Access Compliance Report

Public Rights-of-Way

(Curb Ramps)

Intersection ID: 52611	Main Street: SENATOR_ROYALL_DR	Cross Street: HERITAGE_POND_DR	Location:	N
ADA ID: CFA22E836A83	Ramp Type: Perp	Initial Pass/Fail: Fail	Overall Compliance: No	Severity Score: 25
Codes/Mitigation Info/Possible Solution		Field Measurements/Component Compliance

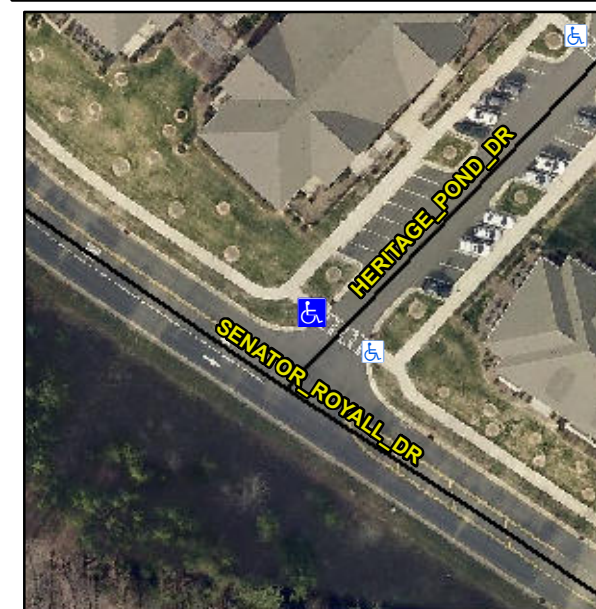
R304.2.2

Compliance	Description	Data	Compliance	Description	Data
N/A	Ramp Length (in)	88.0	No	Ramp Slope (%)	14.7
Yes	Ramp Width (in)	85.0	Yes	Ramp XSlope (%)	0.6
N/A	Flare Type LT	N/A	N/A	Flare Type RT	N/A
N/A	Flare Slope LT (%)	N/A	N/A	Flare Slope RT (%)	N/A
N/A	Flare Traversable LT?	N/A	N/A	Flare Traversable RT?	N/A
N/A	Landing Length (in)	N/A	N/A	DWS Provided?	N/A
N/A	Landing Width (in)	N/A	N/A	DWS Contrast?	N/A
N/A	Landing Slope (%)	N/A	N/A	DWS Length (in)	N/A
N/A	Landing X Slope (%)	N/A	N/A	DWS Full Width?	N/A
N/A	Landing Curb? (Y/N)	N/A	N/A	DWS Offset (in)	N/A
N/A	Shared Landing?	N/A			
N/A	Gutter Ponding?	N/A	N/A	Gutter Slope (%)	N/A
N/A	Gutter Lip Ht (in)	N/A	N/A	Gutter X Slope (%)	N/A
N/A	Painted X Walk1?	Yes	N/A	Painted X Walk2?	N/A
	X Walk 1 Direction	To SE		X Walk 2 Direction	N/A
N/A	X Walk 1 Width (in)	104.0	N/A	X Walk 2 Width (in)	N/A
	X Walk 1 Slope (%)	1.4		X Walk 2 Slope (%)	N/A
	X Walk 1 X Slope (%)	0.7		X Walk 2 X Slope (%)	N/A

Remove & Replace Entire Ramp.
